1963 - 1965 Corvette: Service Bulletin: Air Gaps - Corvette Folding Top-To-Body Panel

Source: Chevrolet Technical Service Bulletin

Bulletin Number: TSB #1097, Section I

Date: February 11, 1965

FIGURE 1 - REAR BOW WEATHER SEAL DETAILS

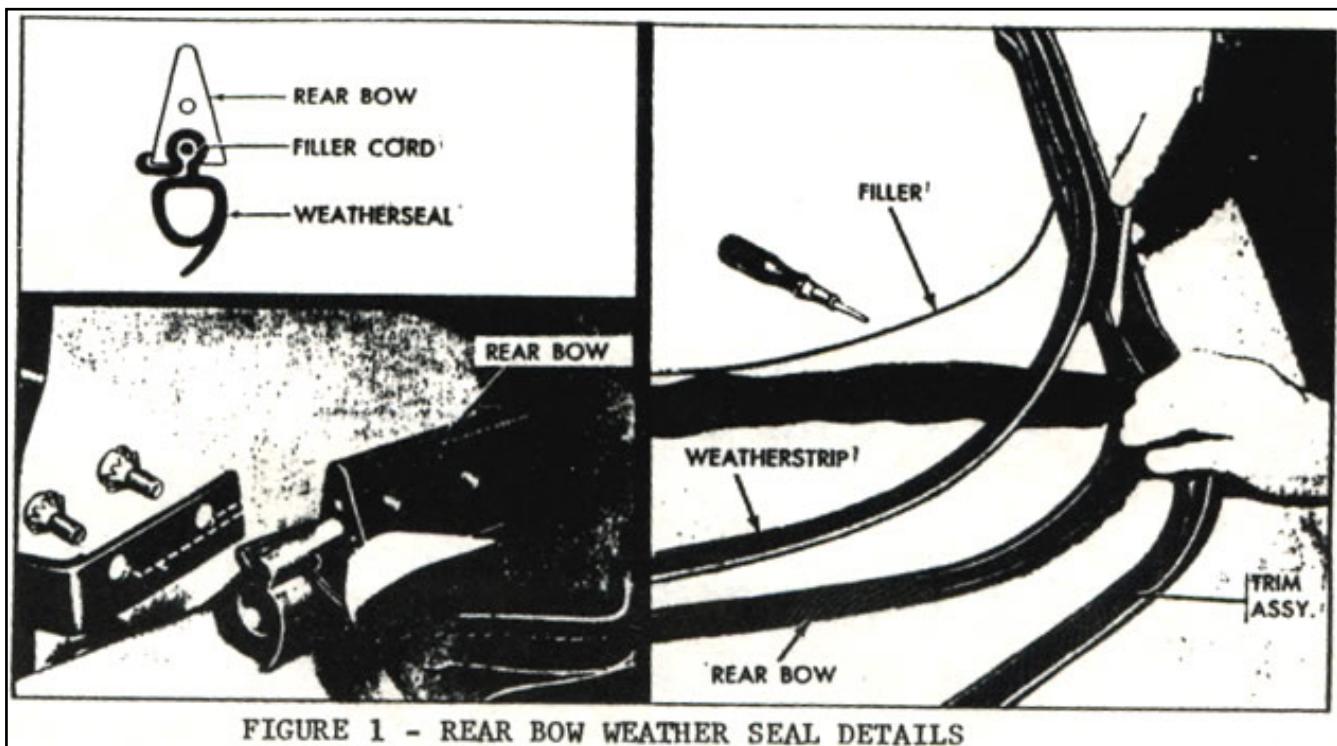
Corvettes, with folding top, may exhibit excessive gaps between rear bow weatherstrip and body panel in right and left rear quarter areas. These gaps are frequently sufficient to permit objectionable air and water entry and may be encountered on 1963-64 and early 1965 units.

A new weatherstrip which incorporates a seal with 1/4" greater height entered production effective with Serial #S108326.

The rear bow weatherstrip is retained in the bow by the installation of a filler cord which causes the upper bead of the weatherstrip to expand within the retainer channel (Figure 1).

Field complaints on this condition can be corrected by installation of the new weatherstrip, Part No. 3873761, per attached instructions.

1. Remove the weather seal by first removing the filler cord and then pulling the seal from the retainer channel of the bow.
2. Install the new seal by starting at the middle of the bow and the middle of the seal and work outward in both directions. The center portion of the seal should be installed dry to anchor the seal while installing the remaining portions. Apply liquid soap or silicon spray to the top of the seal to aid installation. Lubricate and work with no more than 12" section of the seal at a time, alternately from right to left side.
CAUTION : Do not stretch the weatherstrip on installation as this will cause distortion and poor sealing.
3. Lock the weatherstrip by installing the filler cord.
